**Liverpool Range Wind Farm Pty Ltd.**  
**Application number SSD-6696-MOD-1**  
**Turbine and infrastructure changes**

I strongly **OBJECT** to the above application for modifications to the Liverpool Range Wind Farm and I would like to note that I absolutely **OBJECT** to the already approved project.

#### **Appendix C RESIDENCES (Sonus Pty Ltd page 43)**

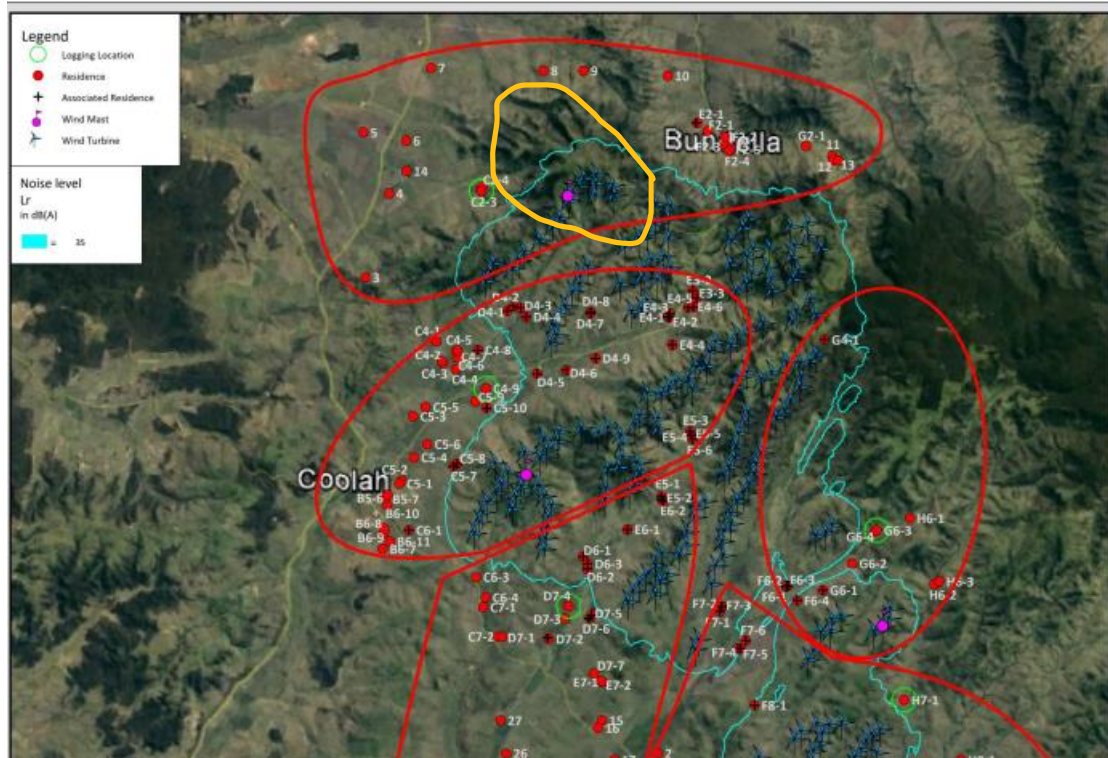
This figure shows the grouping of residences represented by the background noise monitoring location undertaken by Sonus Pty Ltd

Our residences G2-1, 11, 12 & 13 are represented by noise logger C2-3.

Residence C2-3 where the noise logger was situated is on Binnia Hills Road, this is approximately 22.6km as the crow flies from our residences 11, 12 & 13.

I firmly believe that the data from this logger could in no way accurately represent the noise that we will experience at our location. We are surrounded by vast undulating hills, how can one sound logger represent that many residences (17) when the distances and land area between are so vast?! The surroundings in our area are immensely different to that of C2-3. For a start there is a range in-between our residences and that of C2-3 which is approximately 1000m above sea level which I have circled in yellow on the picture below.

We are in no way on the same side of the wind farm as the logger location C2-3. This shows that the methodology in the location of the noise loggers is incorrect and shouldn't apply to us in our location. This is not acceptable and shows the modification application is actually flawed and contains errors - this needs addressing before any consideration is given to this modified project!
